CITY OF ALBUQUERQUE

RE: Olague Warehouse – 1212 3rd St. NW
Grading Plan
Stamp Date: 9/20/17
Hydrology File: J14D184

GRADING & DRAINAGE PLAN

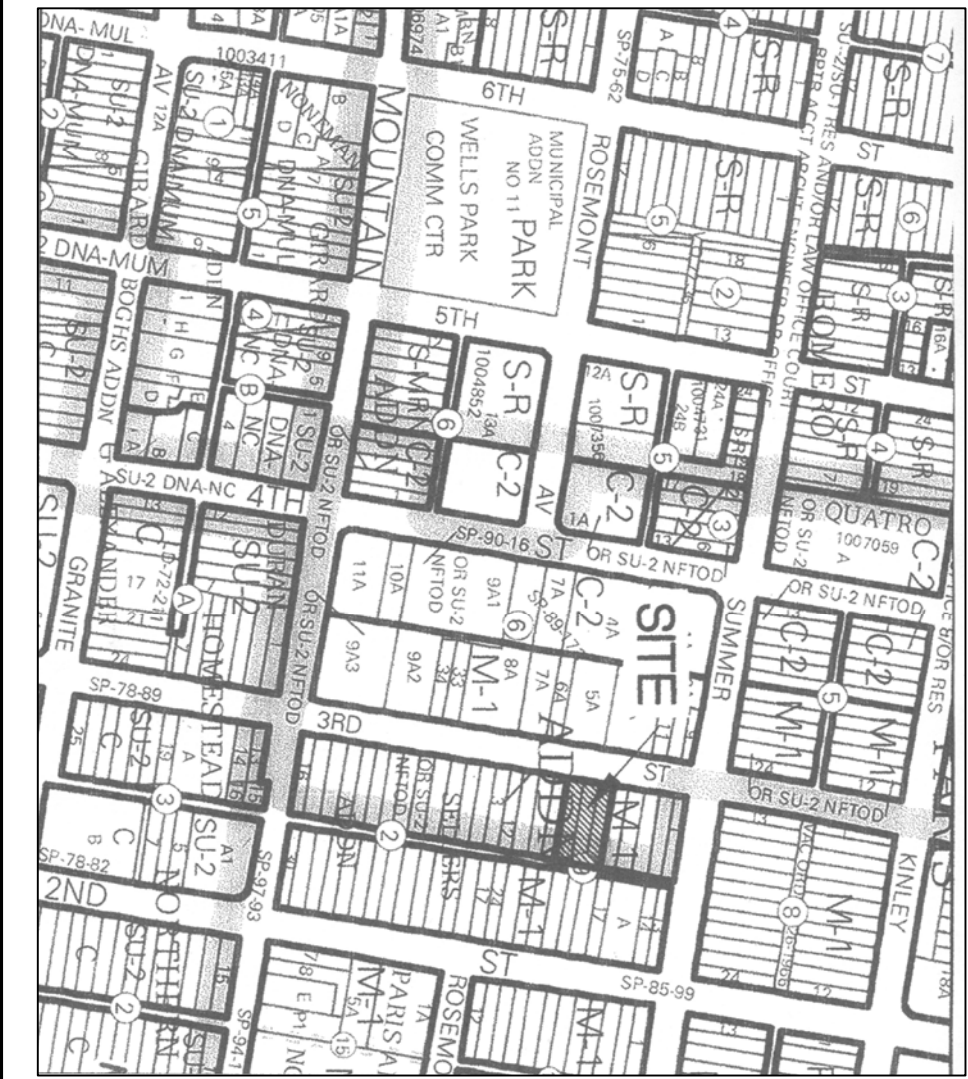
1. As per the DPM Chapter 22, Section 5.G (Flat Grading Scheme), The required 100 year 10 Day retention volume should have been 1,228 CF instead of the noted 1, 045 CF.
2. Please provide more detail and calculations for each retention pond, so the volumes can be verified.
